T10/07-361r0

To	From	Subject	Date
INCITS T10 Committee	Curtis Ballard, HP Michael Banther, HP	SSC-3 Out of Band Encryption Key Management	28 August, 2007

Figure 8 — UML example of SCSI target device and physical device

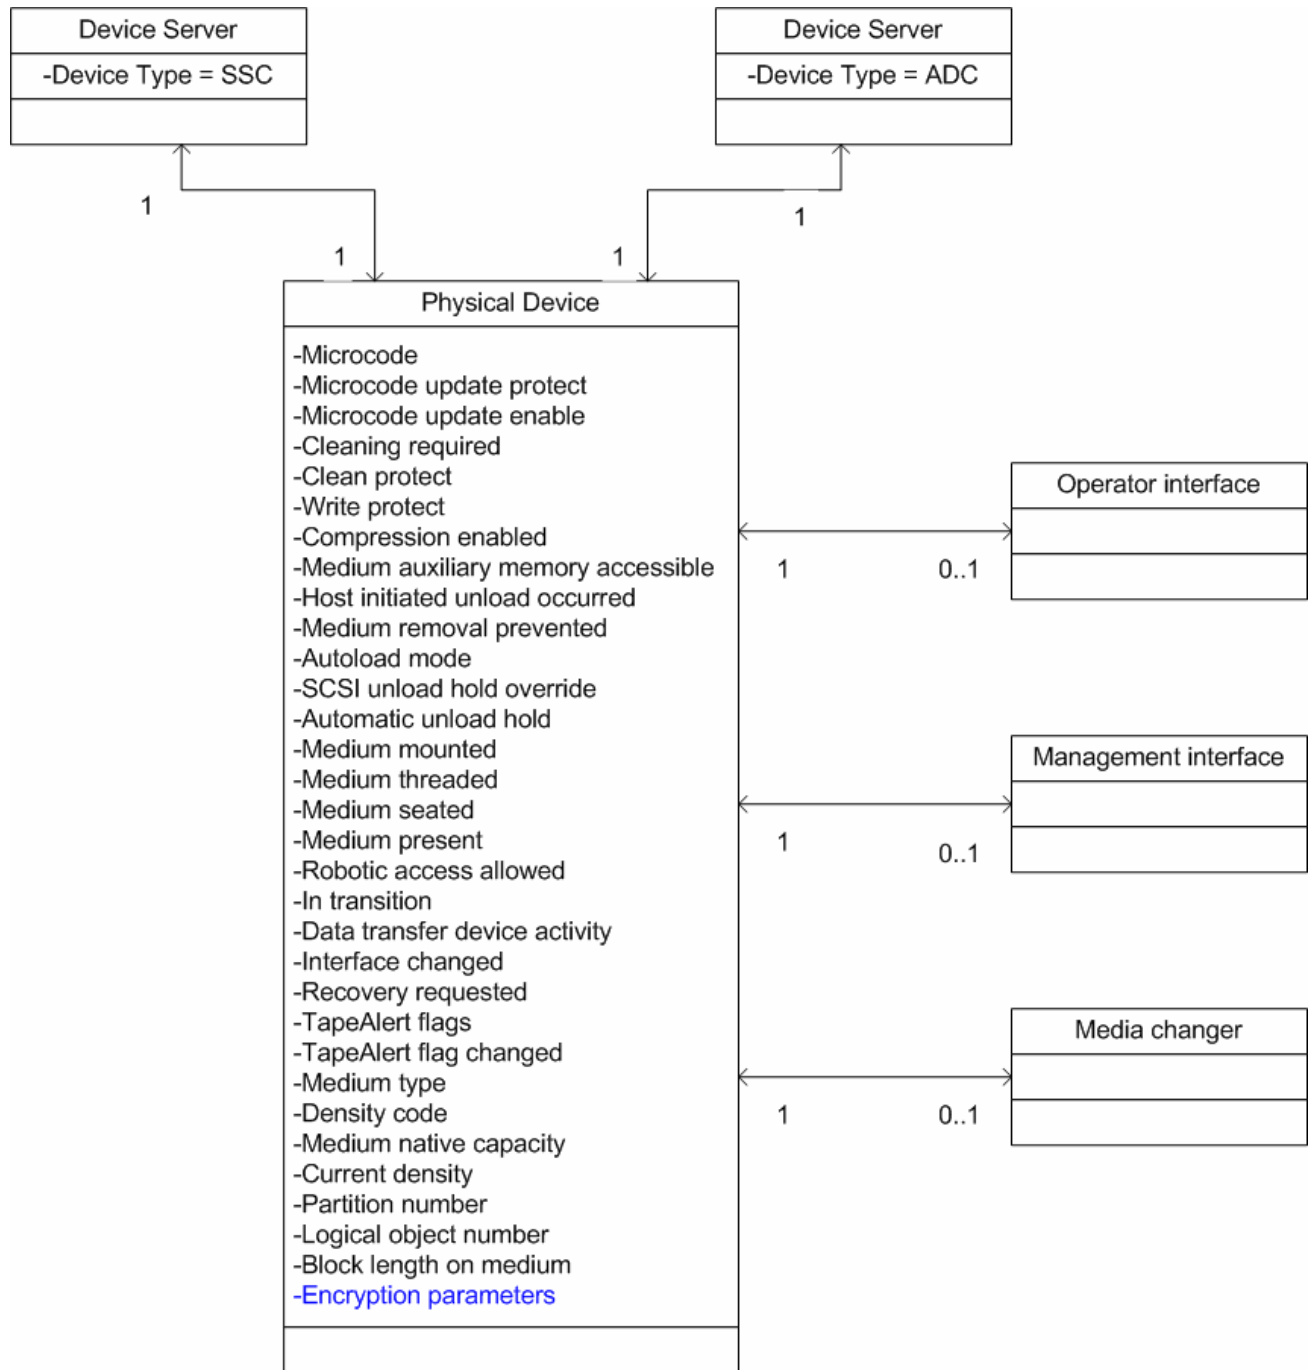
Add encryption parameters to list of items in physical device in figure 8.
